ANN ARBOR PLANNING DEPARTMENT STAFF REPORT

For Planning Commission Meeting of December 15, 2015

**SUBJECT: NorthSky – Zoning & Site Plan for City Council Approval
(2701 Pontiac Trail)
Project Nos. Z14-027, SP14-053**

SITE PLAN for CITY COUNCIL for NORTHSKY

U:\13-174\dwg\Preliminary Site Plan\44 Multi-Family - Layout Plan.dwg, 44 Multi-Family - Layout Plan

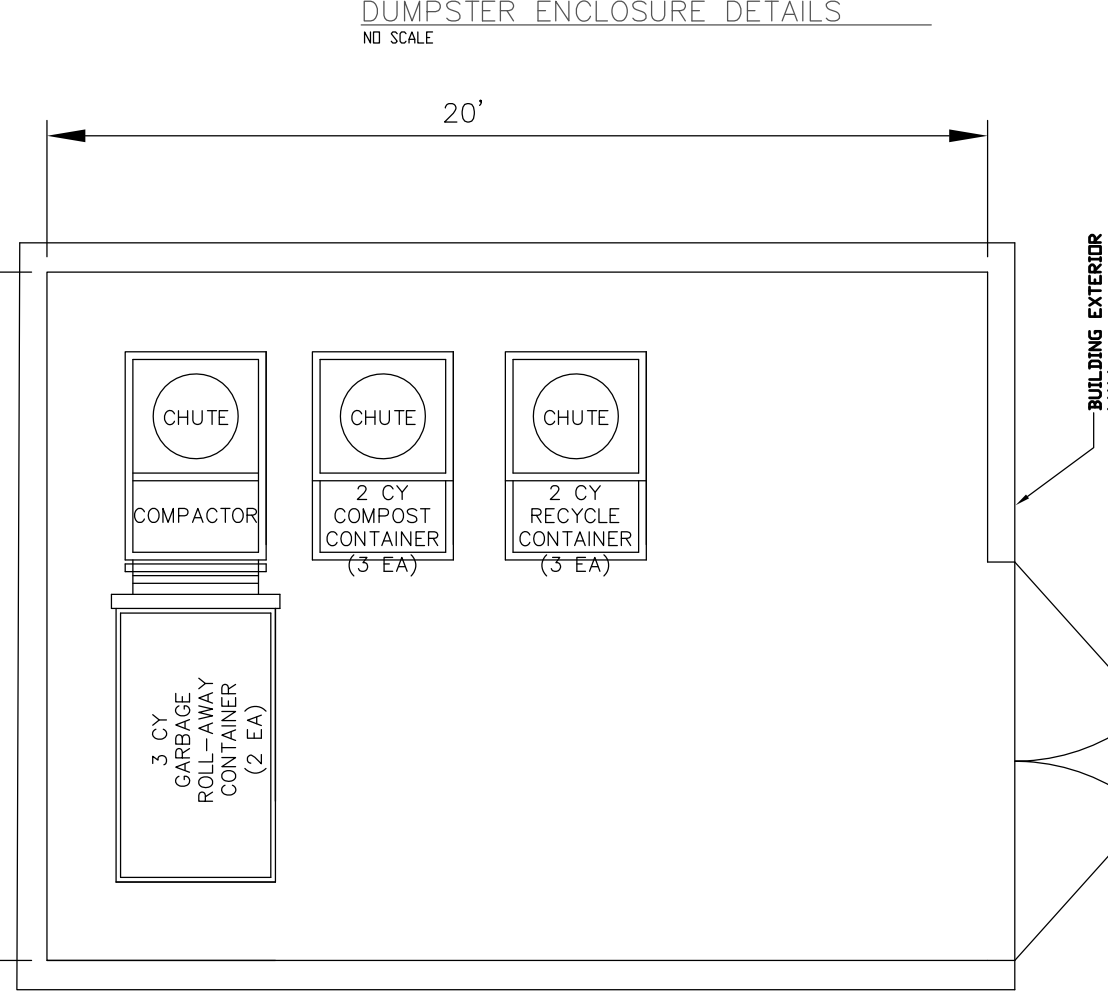
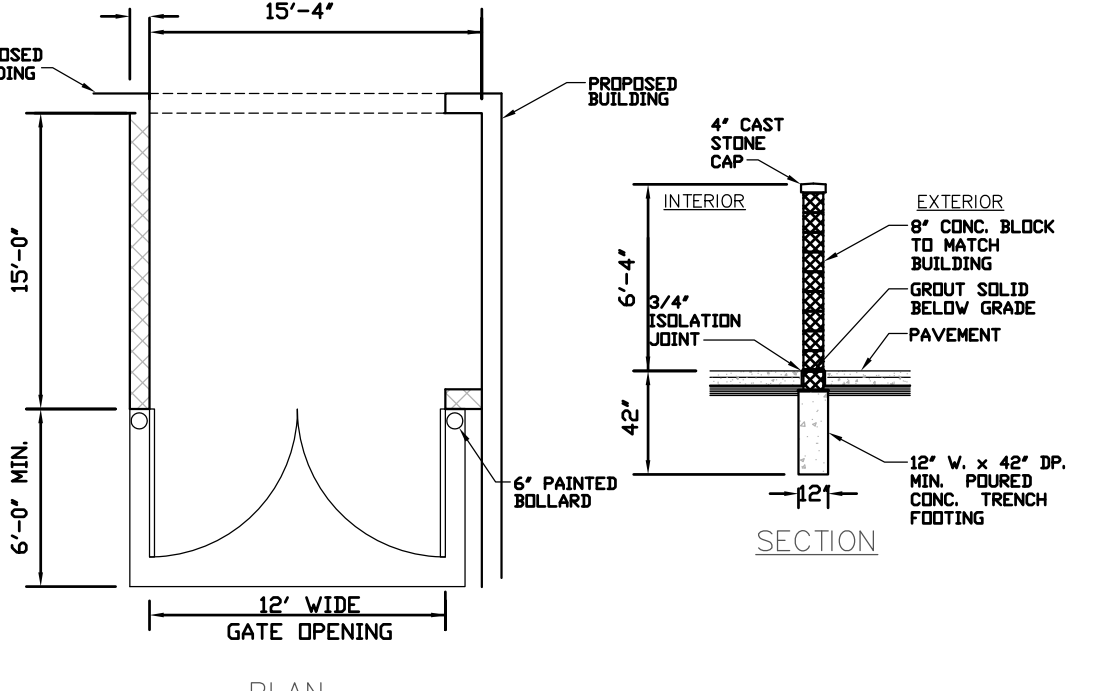
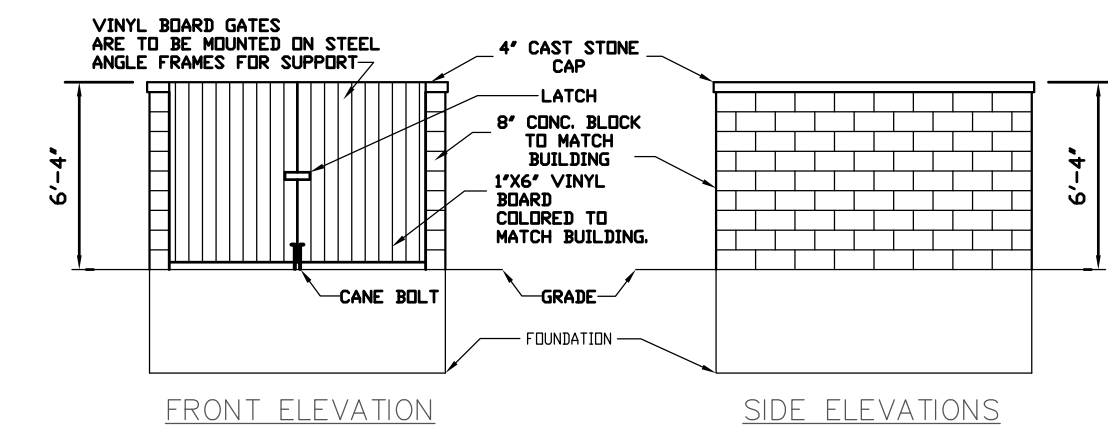
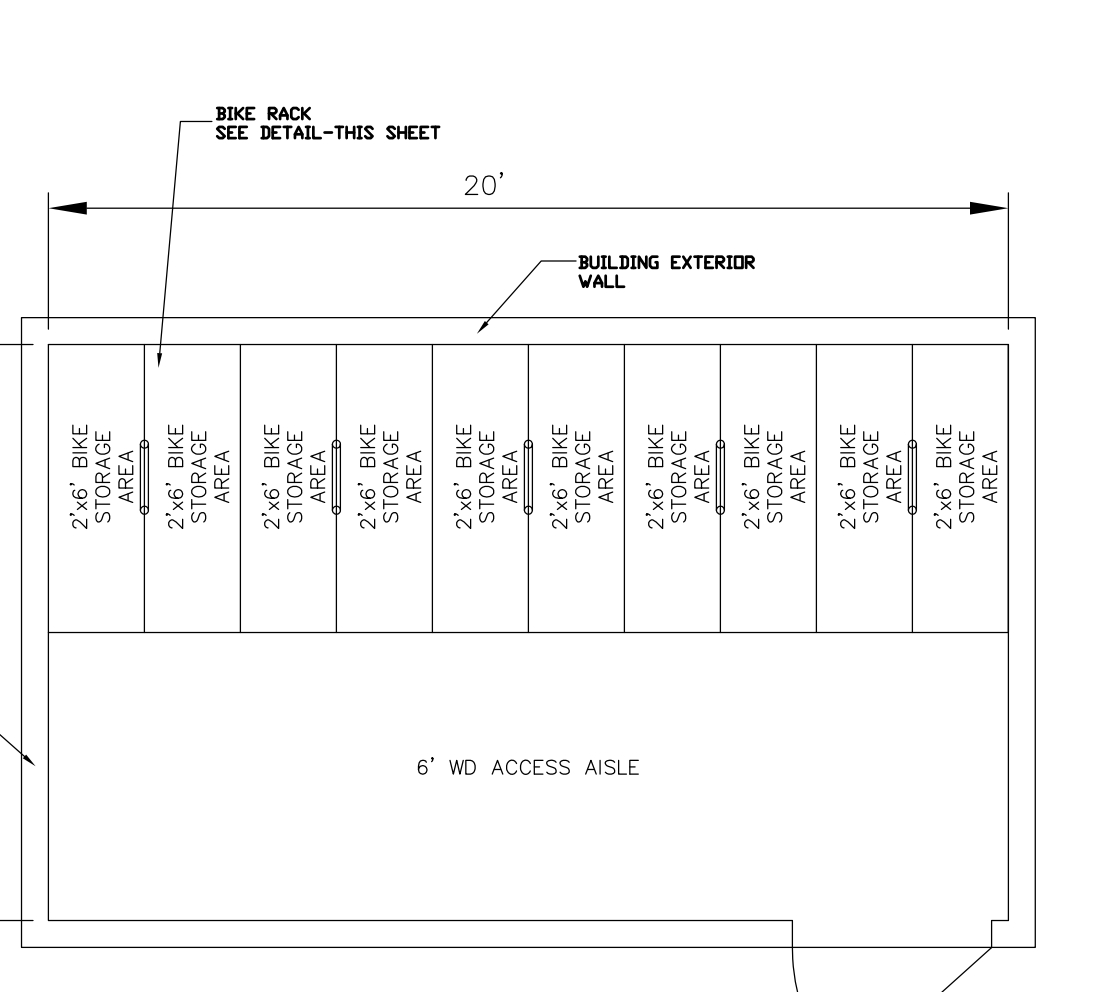
There is a discrepancy between the comparison table on sheet 8 and the parking layout on sheet 44 that will be corrected before the petition advances to City Council. The table will be

changed to show 14 bicycle parking spaces for the multi-family building: 10 class A in the bike room, and four class C near the east entrance.
